ADDENDUM

Date Issued:	Jan 7, 2025
Project:	Intermountain Health RAD Room Remodel 3741 West 12600 South Riverton, Utah 84065
Addendum Number:	1

Riverton Hospital Radiology Room Remodel

Subject: Intermountain Riverton Hospital Radiation Room Remodel – Structural Evaluation

Demo and
New Floor
Plan Level 1

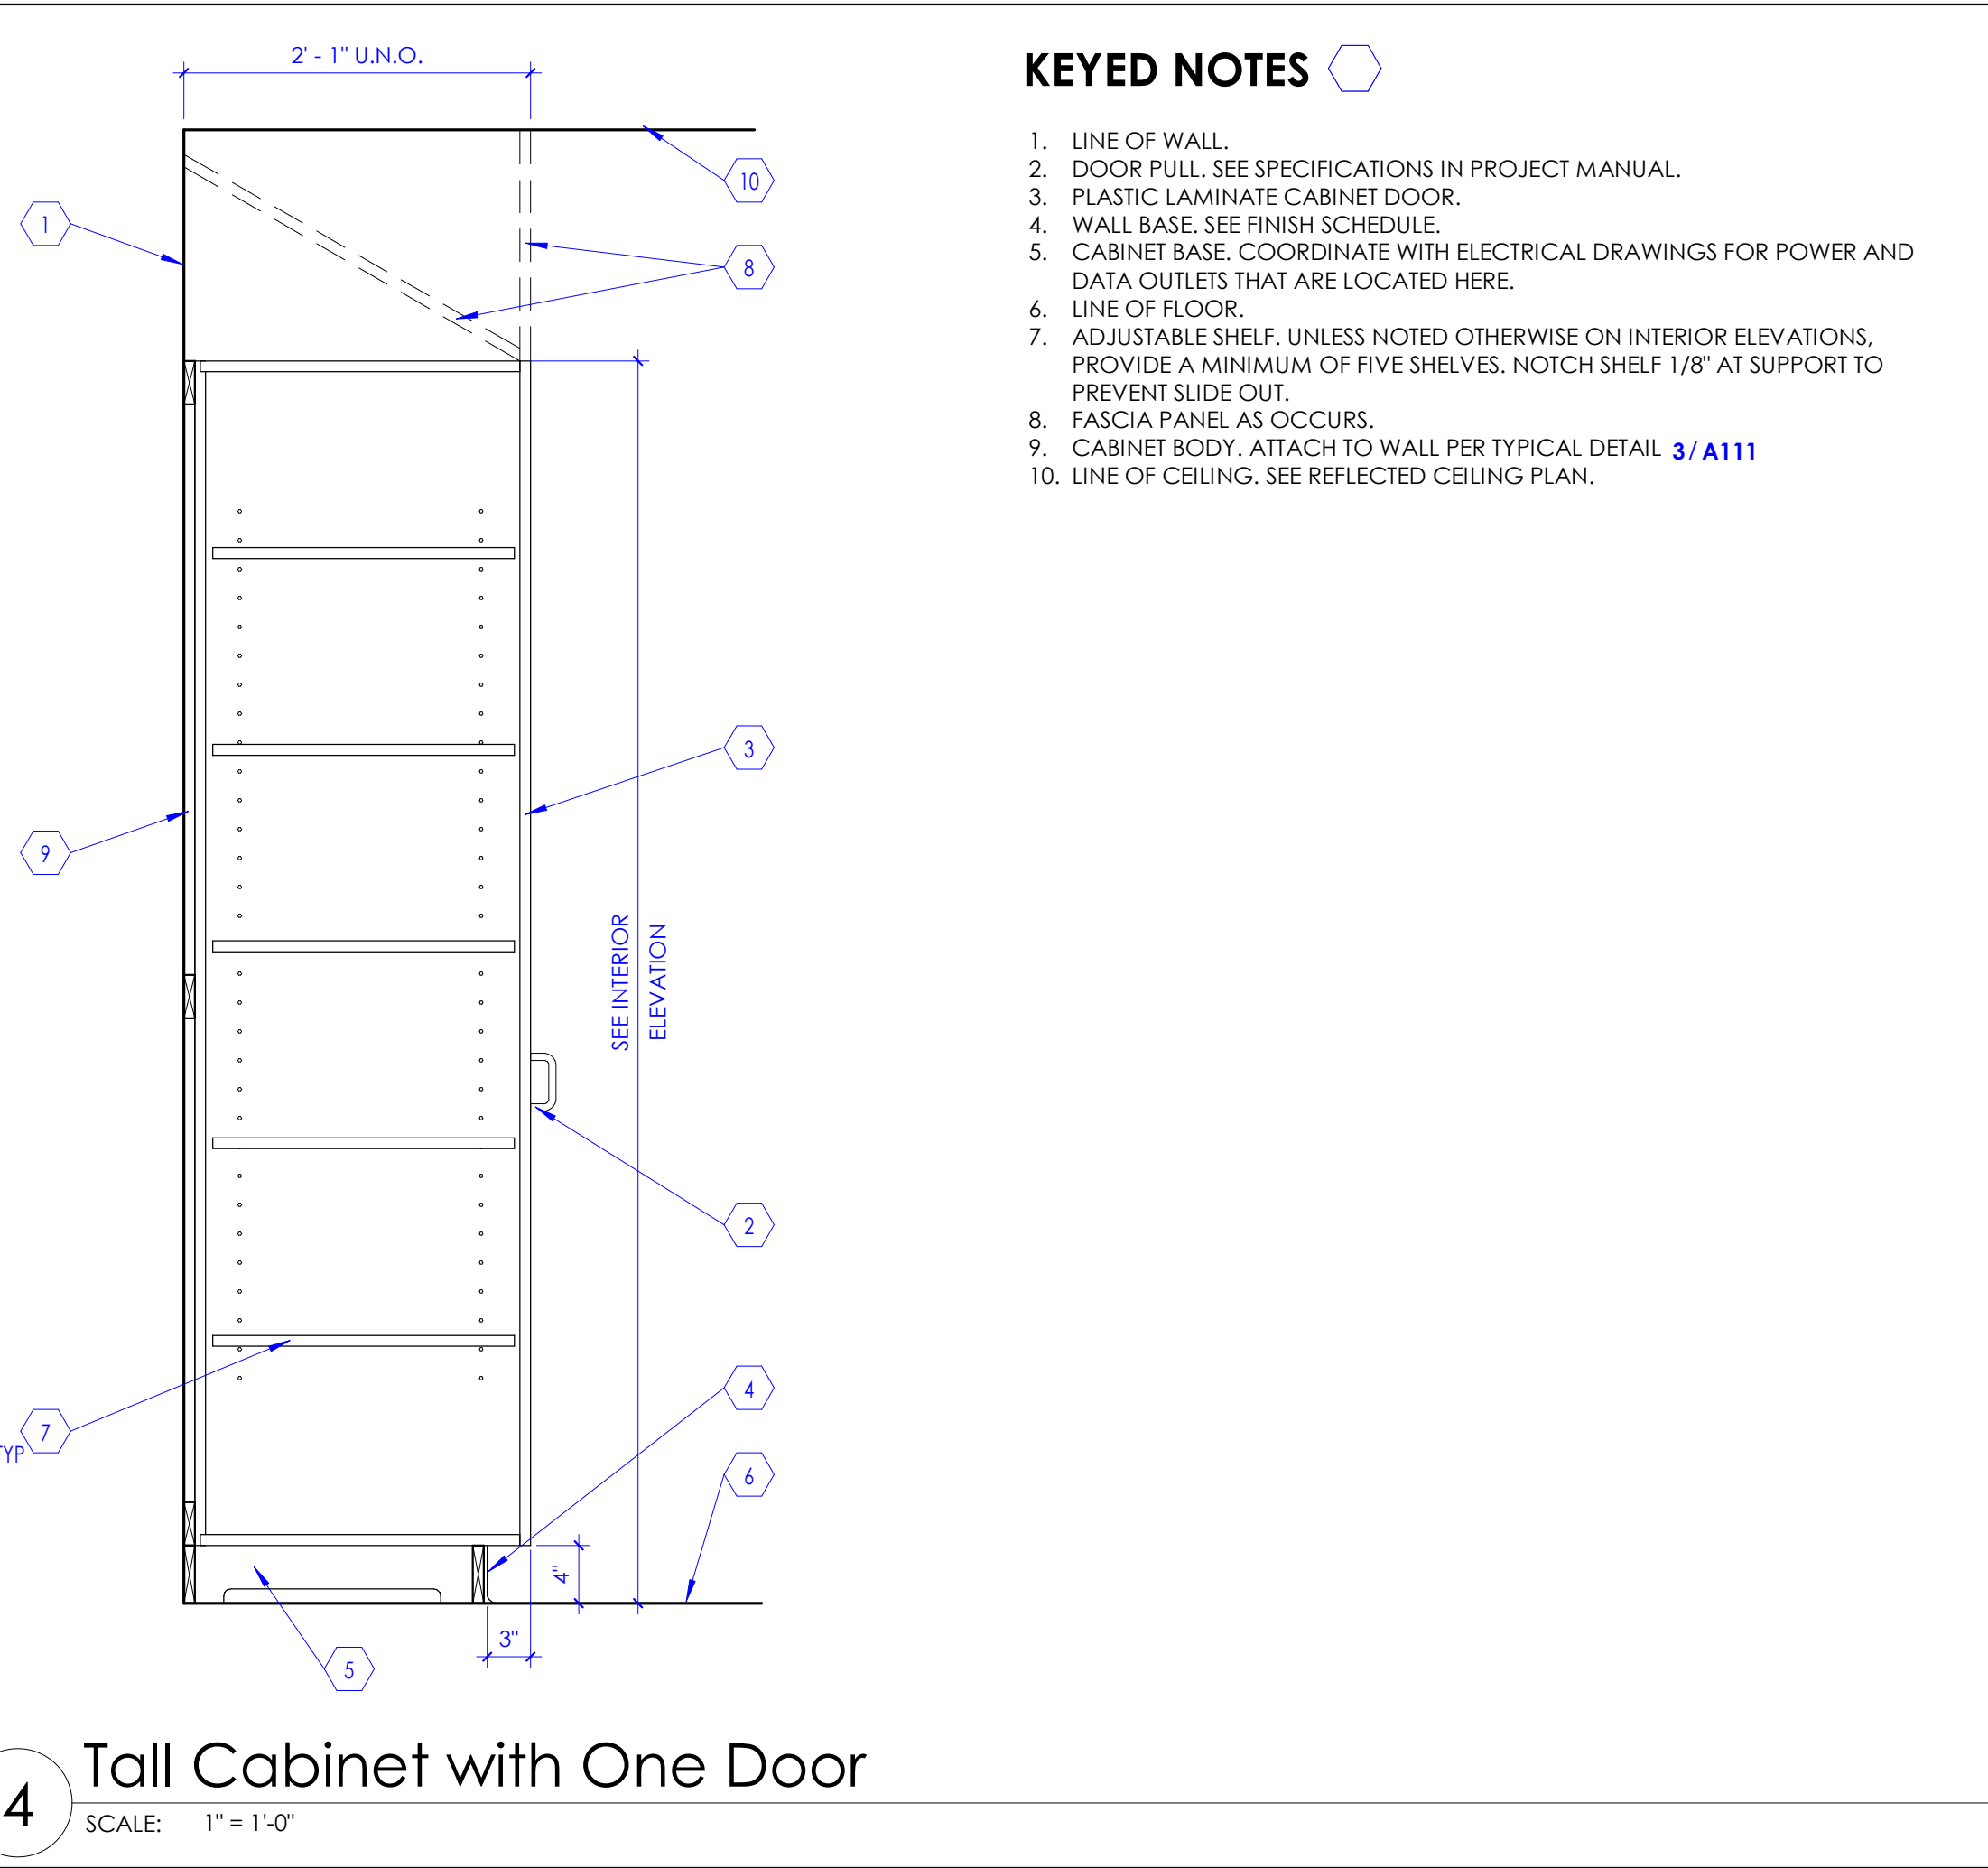
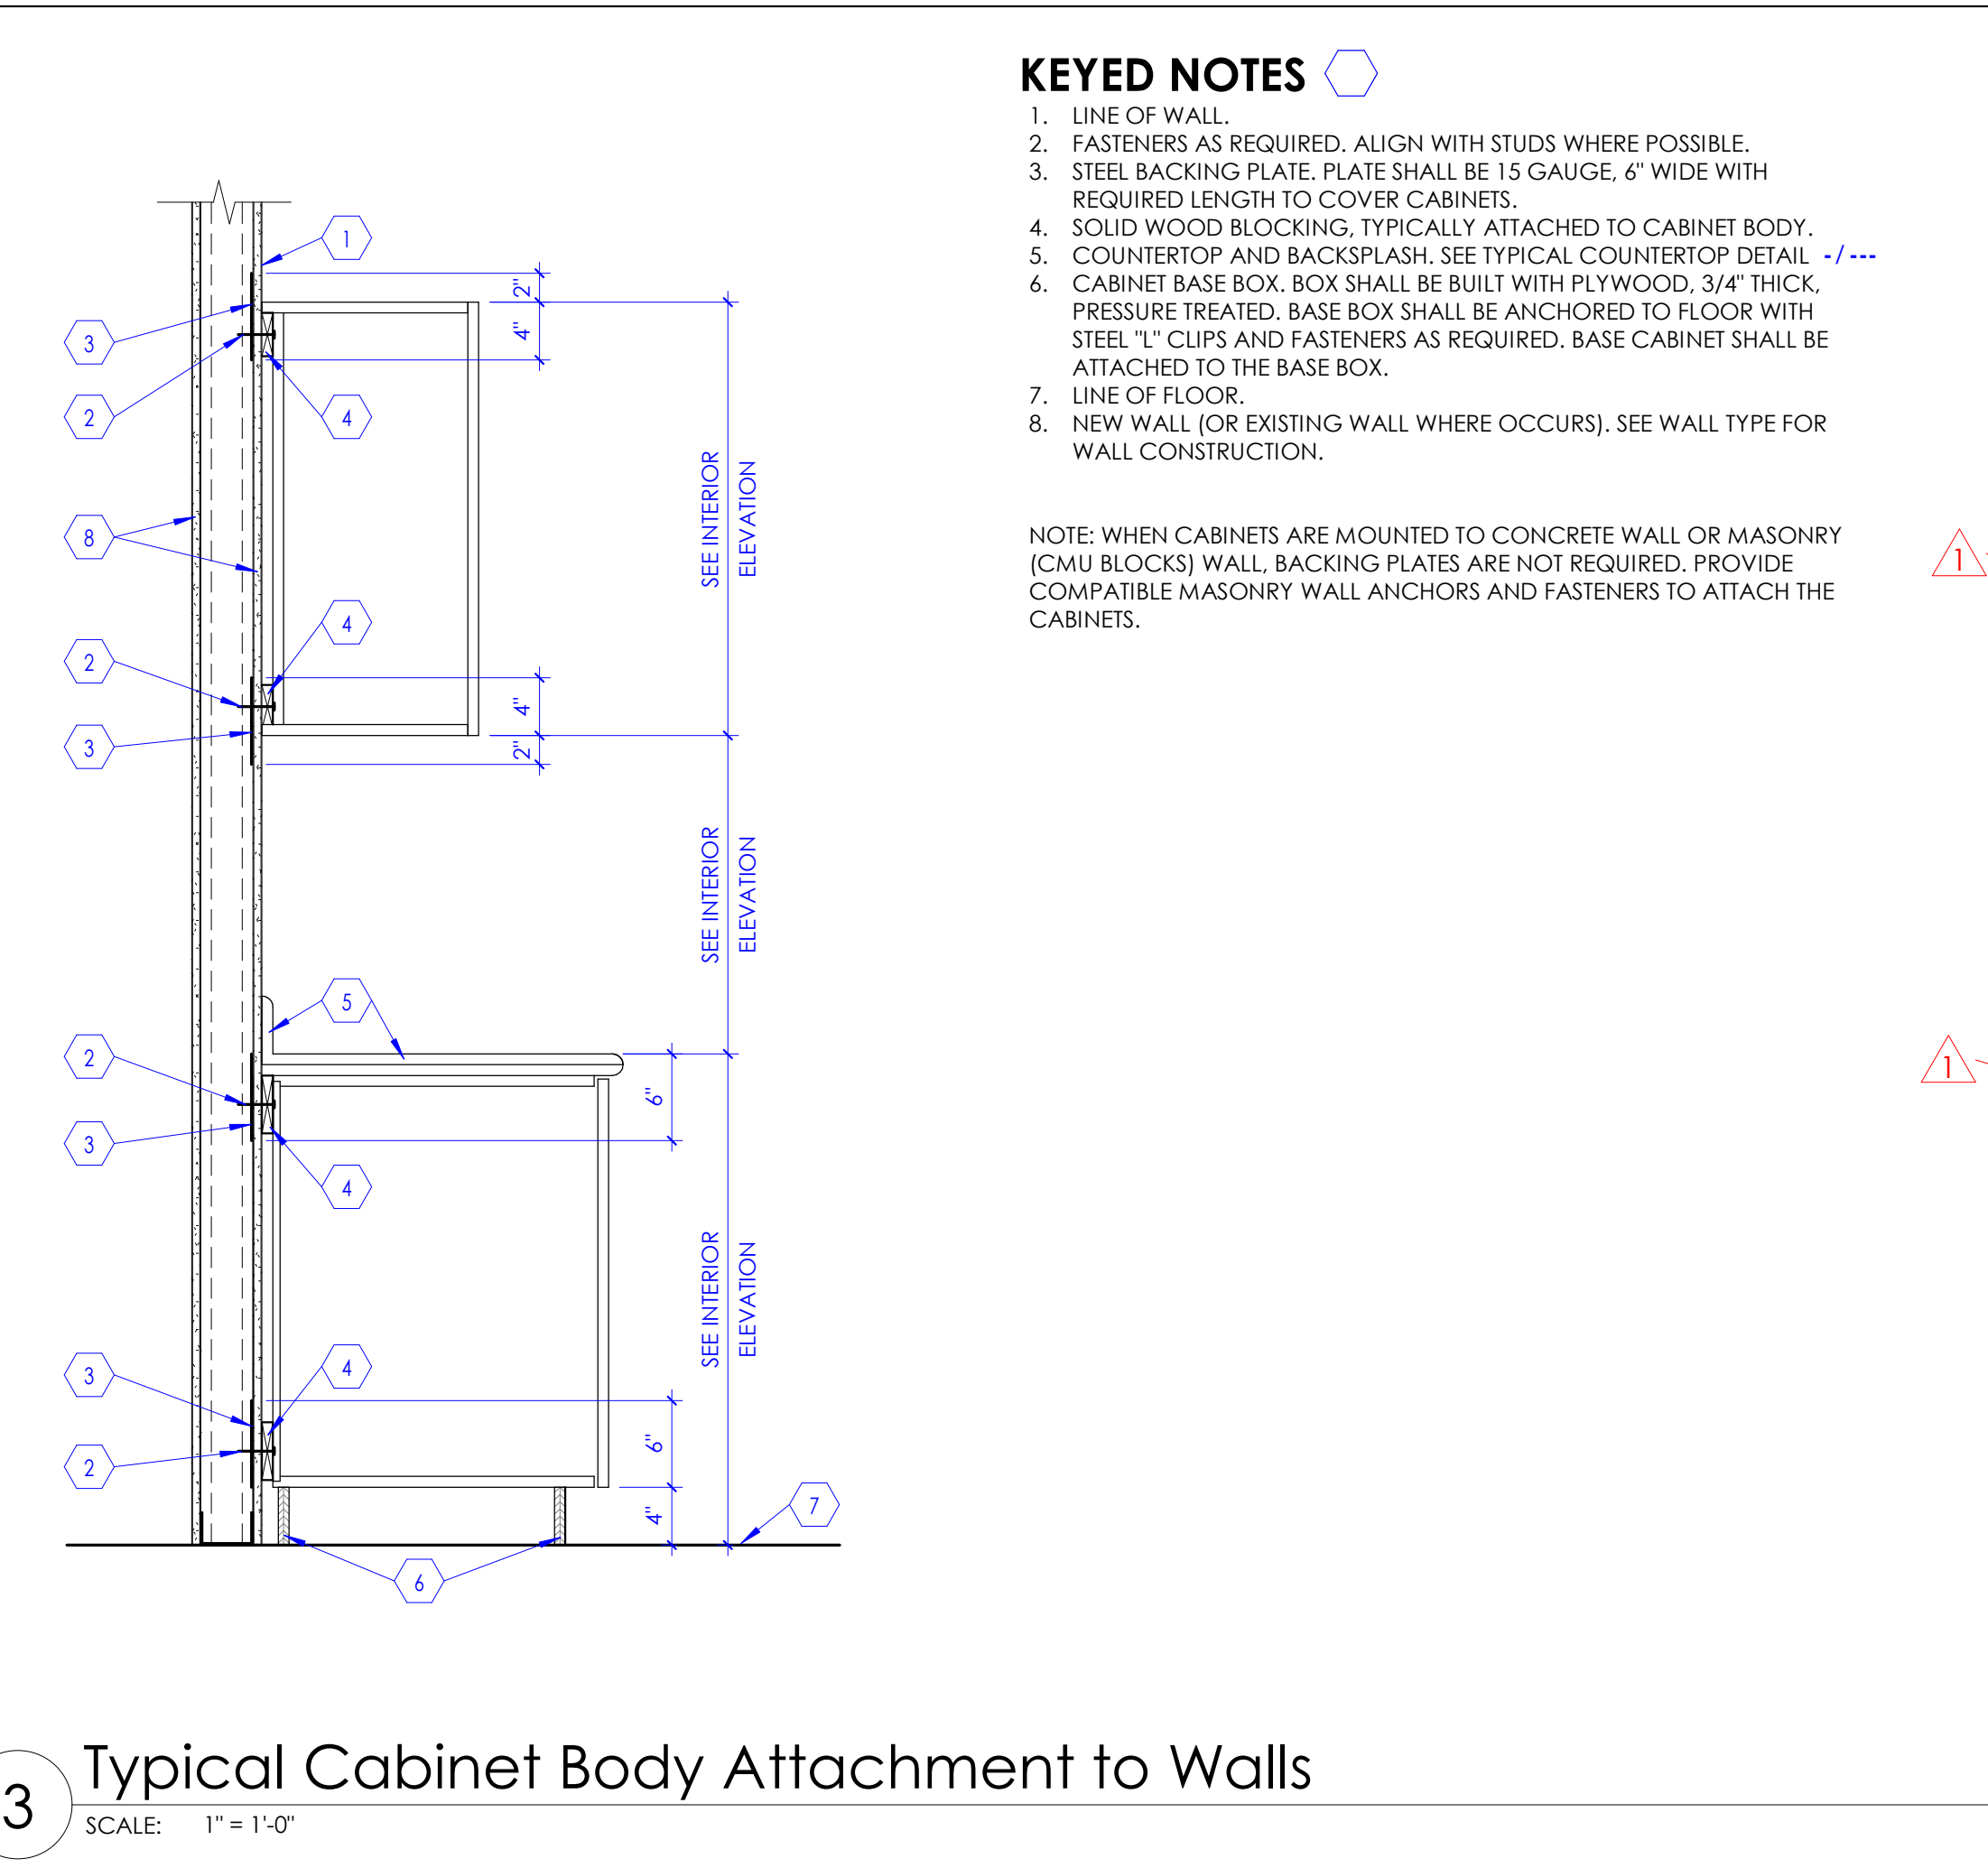
Sheet Number	Drawings
Architectural Drawings	
G001	Revise note for vendor equipment installation as indicated.
A110	Add sheet. Add keynote 01.15 as indicated.
A111	Revise ICRA barriers as indicated. Add keynote 01.13 and 09.25 as indicated.
A112	Add keynote 21.01 as indicated.
Structural Drawings	
S100	Add sheet.

- 01.13 CONTRACTOR SHALL BE RESPONSIBLE FOR DISPOSING OF VENDOR'S EQUIPMENT PACKAGING. COORDINATE WITH VENDOR AS REQUIRED.
 - 02.18 FLOOR COVERING EXISTING TO BE REMOVED. REMOVE FLOOR COVERING ONLY BENEATH EXISTING X-RAY TABLE. REMOVE COVERING TO EXISTING SEAM IN FLOOR.

- 09.25 PATCH WALLS AS REQUIRED WITH EQUIVALENT LEAD (Pb) SHIELDING. SEE PHYSICIST'S REPORT.
 - 11.08 X-RAY EQUIPMENT. NOT IN CONTRACT. VENDOR INSTALLED. COORDINATE WITH EQUIPMENT VENDOR AS REQUIRED. SEE ELECTRICAL DRAWINGS. SEE VENDOR DRAWINGS.
